**Subject: Response to Second Notice of Deficiency (NOD)
Fairbanks Landfill – Harris County
Municipal Solid Waste (MSW) – Permit Application No. 1565B
Major Permit Amendment Application – Notice of Deficiency (NOD)
Tracking Nos. 17465613 & 17978769; CN602560930/RN100218544**

Attachment A: Technical and Rule Compliance Comments

Figure 3D.4.2-1: Example Free Body Diagram at Liner Side Slope

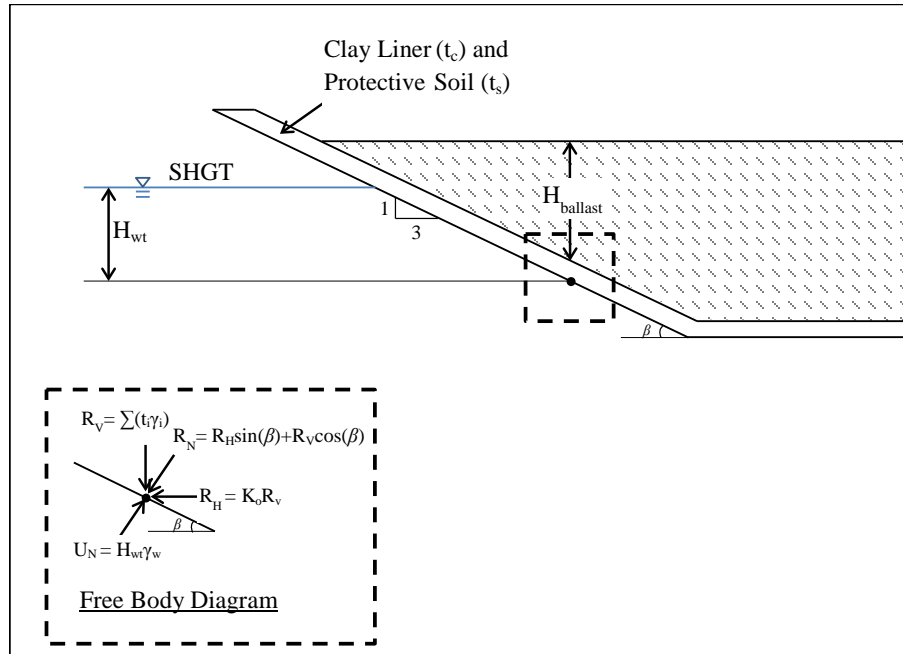
Comment A7: Regarding the response to Comments A61 – Please provide copies of published literature that delineate the principle and the application of the second term in the calculation equation for R_N .

Response to Comment A7: For reference, the second term in the calculation of the resisting force refers to the uplift resistance provided due to the lateral earth pressure of the clay liner. It is also noted that the magnitude of this resisting force is very small and has a very minor contribution towards the overall uplift resistance (i.e., negligible effect on the calculation results). However, the inclusion of this component of the uplift resistance is consistent with geotechnical engineering principles, and as requested, Attachment 3D.4.2 has been revised to include copies of relevant pages of a widely used geotechnical engineering textbook that defines and explains this term.
